Project: IEEE P802.15 Working Group for Wireless Personal Area Networks (WPANs)

Submission Title: [Resolution of comments on Dynamic Data Mode SYNC Length Negotiation]

Re: [Discussion and resolution of LB213 (4ab D02) comment index #s 117, 621 and 622]

The philosophy of the negotiation

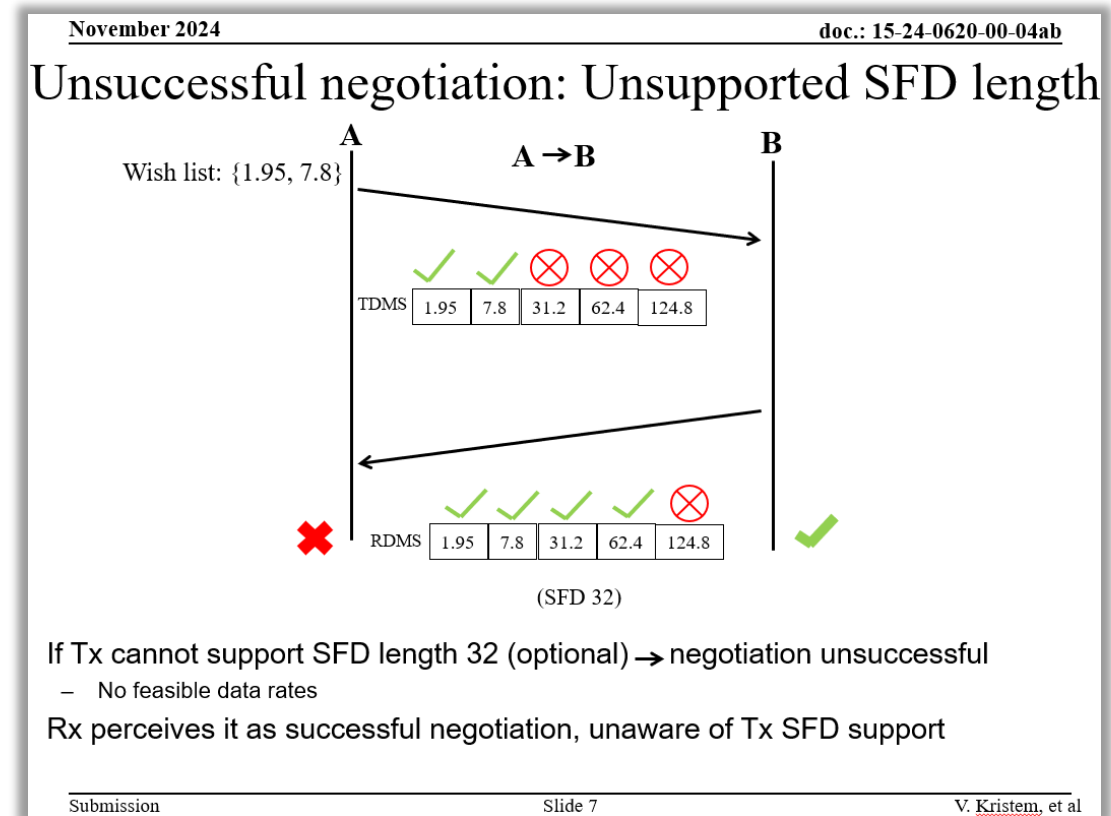
- If it supports LDPC on some or all of the proposed rates it may, (or not), as it sees fit, indicate that too.
 - The transmitter is not obliged to use LDPC on rates where it is indicating support, i.e., (if the receiver supports LDPC on a particular data rate), the transmitter when sending at that rate may choose per frame whether to use LDPC or not. (C1: Propose to note this in 4ab text)

- TX can still opt to only use one length, following the (agreed) rules defined on how to choose the SYNC length.
- Given this is “dynamic data mode” the design expectation is/was that several rates would be proposed, i.e., there would always be at least one mandatory rate in the proposed set.

- C2: Propose to make it rule that the set includes at least one mandatory rate, (and recommend at least two).

(B) SYNC of 192 or 256 symbols

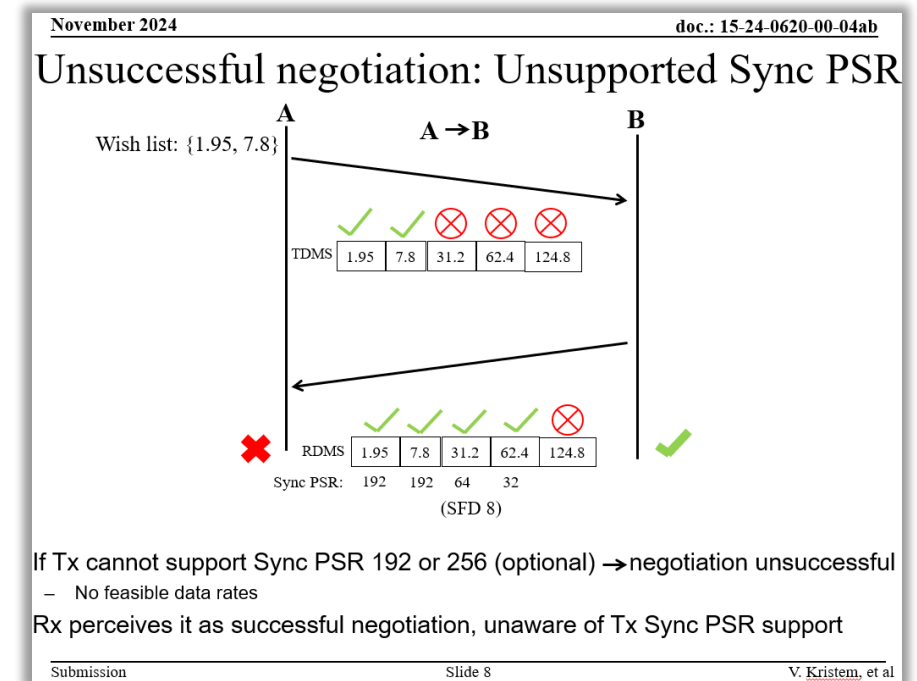
- In this example the receiver is selecting a SYNC length of 192 for the two rates that the transmitter has indicated it wants to use.
 - (SYNC lengths for rates TDMS hasn't proposed are meaningless)
- This is a shortcoming, since the text describing the TX SYNC length choice does not properly cover the case of these longer SYNC lengths where there isn't a higher mandatory SYNC length.

Since the RDMS may indicate different SYNC PSR values for different data rates, the specified operation with respect to this is as follows: Subsequent to a TDMS/RDMS exchange, the transmitter shall use those payload data rates and coding methods that the receiver has indicated it can support, and the transmitter shall use the SFD requested by the receiver, and a SYNC length from Table 58 that is no shorter than that requested by the receiver for the selected payload data rate and no longer than the largest SYNC indicated in the Receiver Data Mode Specifier (RDMS) for any data rate, except in the case where the transmitter cannot support sending an optional SYNC length in which case it shall use the next higher mandatory SYNC length.

- (a) Make 256 also a mandatory TX length.
 - (b) **C5:** At the end of the paragraph, add “or otherwise the highest mandatory length”
- It is expected (b) will be preferred over (a)

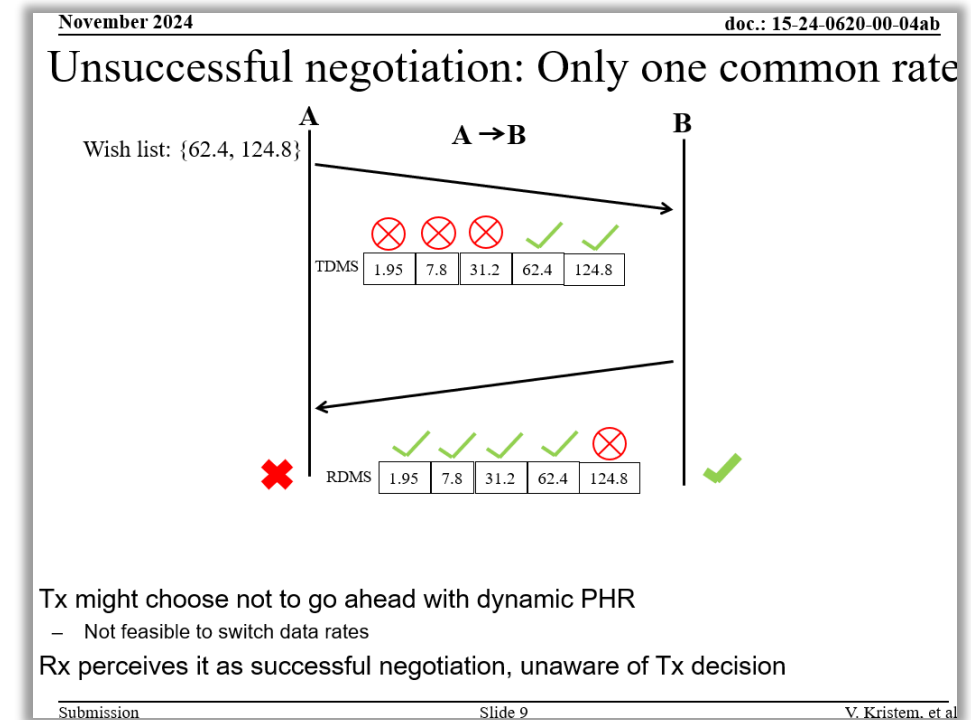
Note: on the negotiation image, the RDMS since values for 31.2 and 62.4 are unused the receiver essentially just selecting length 192 sync

(D) Asymmetric failure case

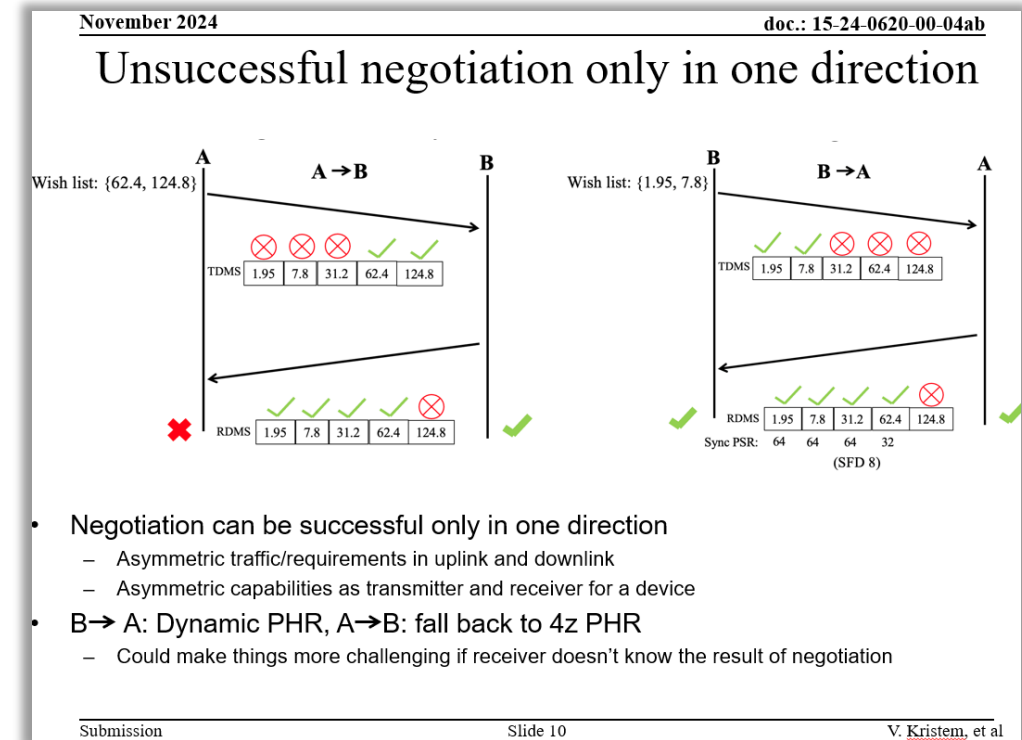
- As per previous sheet, case (C), there is no failure since the use of the dynamic PHR is required
 - There is no fallback to 4z PHR considered as part of this negotiation procedure
- The negotiation has successfully decided:
 - Direction A → B uses 62.4 Mb/s
 - Direction B to A uses 7.8 Mb/s and 1.95 Mb/s

In this scenario Device B having the knowledge that Device A is intending to operate in an environment where the link supports 62.4 Mb/s might logically include 31.2 Mb/s and 62.4 Mb/s in the set of rates in its TDMS field. This indicates a certain asymmetry in the negotiation since B has the TDMS from A before sending its TDMS, as per Figure 190, (reproduced on slide 6 above).

No additional changes needed

We don't need to consider this more. The next higher layer can decide who goes first and agree via OOB methods when to engage in this negotiation or any subsequent re-negotiation should the application needs change. We can note this (C6).
